WEWAHOOTEE PARCEL G

UPDATES:

WEWAHOOTEE PARCEL G

Typical 91' R/W Section

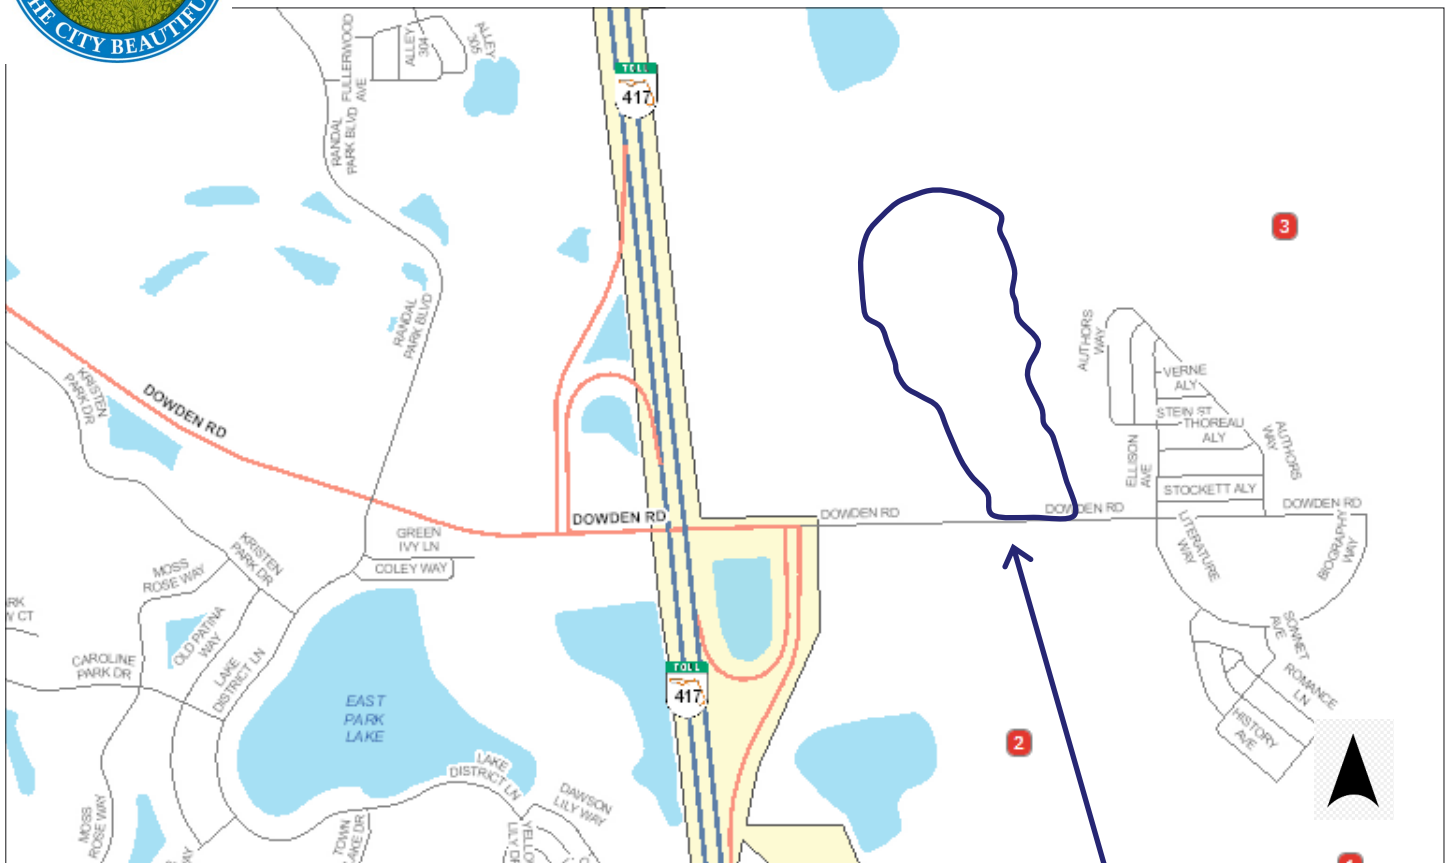
Page 12 Drawing A: The title of the image shall be changed due to the location of the road treatment at the entrance of the site. It will not include on-street parking.

WETLAND BOARDWALKS

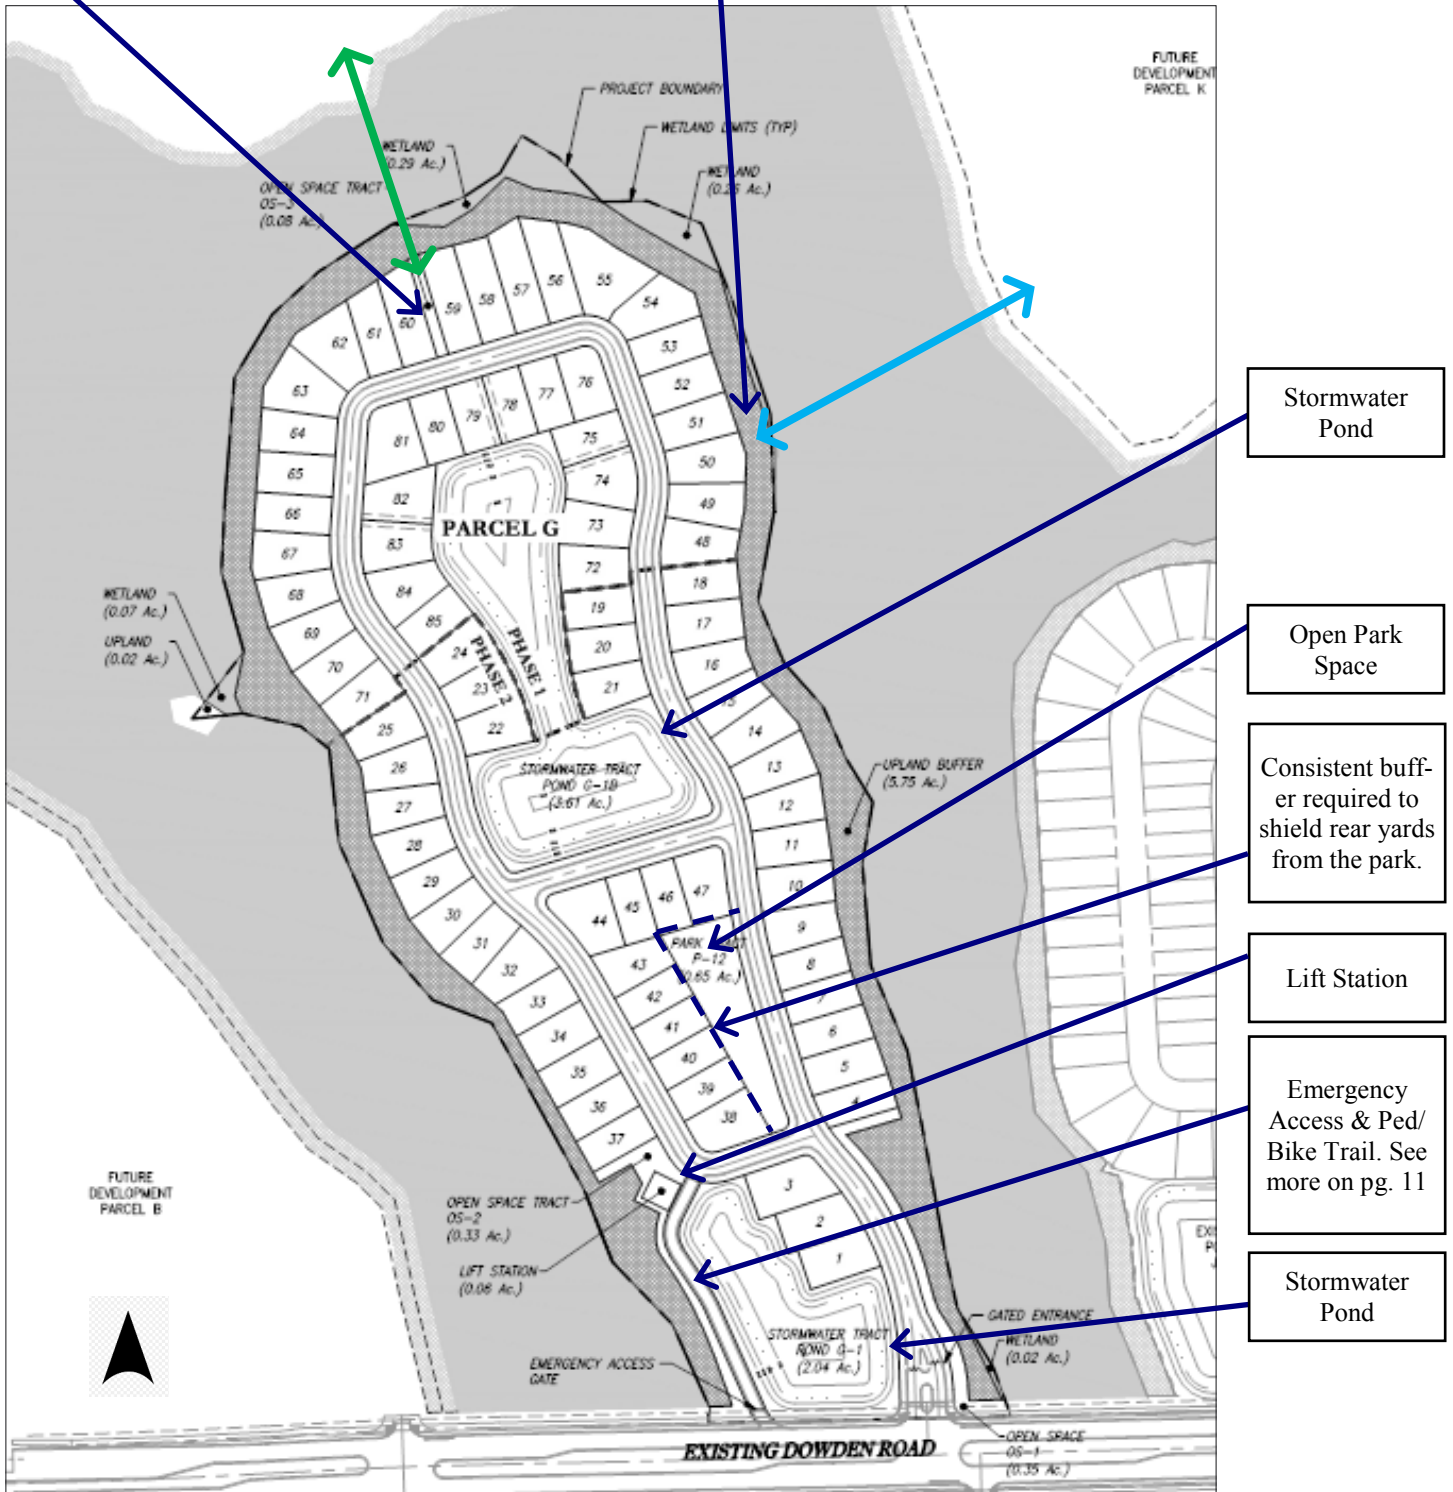
Page 11: The caption shall read:

The wetland boardwalk connection between Parcel G and Parcel R is required. The remaining wetland boardwalk locations will be finalized via determination (LDC2016-00233). Above is an image of the boardwalks at Gatorland Orlando. This is the style of boardwalk the City envisions for the pedestrian and cyclist connections. ~~Consistent with Transportation Planning's conditions, the boardwalk is to be 10 ft. wide.~~ The boardwalks must either be properly lit in accordance with the PD, or it must be posted that the boardwalks are closed at dusk.
